**CITY OF RIVERSIDE COUNCIL MEETING AGENDA**  
**RIVERSIDE CITY HALL COUNCIL CHAMBERS**  
**60 N GREENE STREET**  
SPECIAL MEETING  
Monday, September 30, 2019 – 6:30 P.M.  
COUNCIL WORKSESSION TO FOLLOW MEETING  
**REVISED 9-27-19**

**From:** Scott Pottorff <[S.pottorff@mmsconsultants.net](mailto:S.pottorff@mmsconsultants.net)>  
**Date:** September 26, 2019 at 3:41:47 PM CDT  
**To:** [admin@cityofriversideiowa.com](mailto:admin@cityofriversideiowa.com), [mayor@cityofriversideiowa.com](mailto:mayor@cityofriversideiowa.com)  
**Cc:** Bill Poch <[billpoch@aol.com](mailto:billpoch@aol.com)>  
**Subject:** Bill Poch Culvert to East

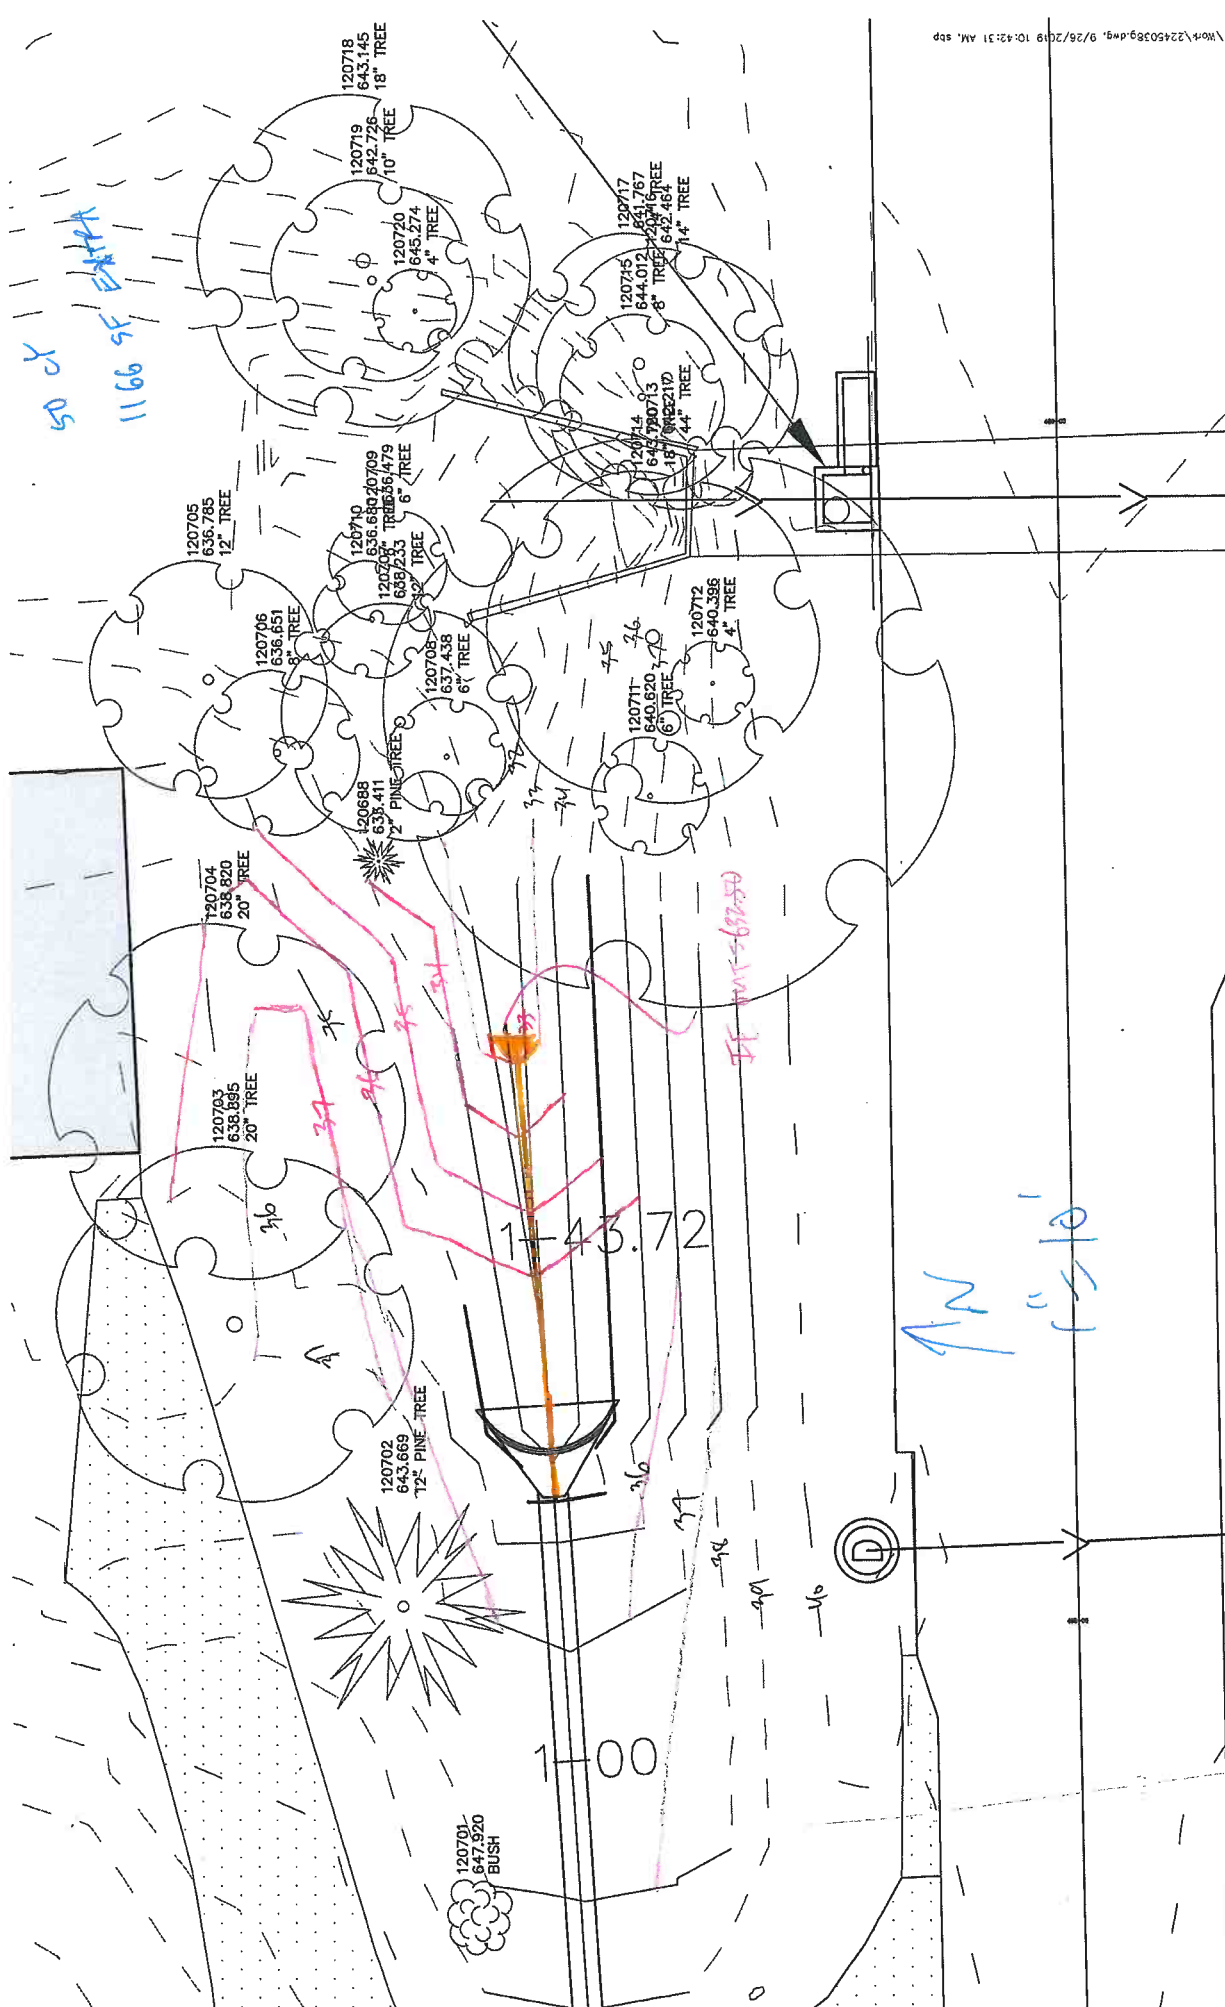
Here is my estimated cost to extend the culvert to the east of Bill's driveway by 32 as I discussed with him last week. This includes a small berm to protect his garage. Attached is a hand sketch of the proposed plan.

I don't see where there is a benefit to the City by doing this work.
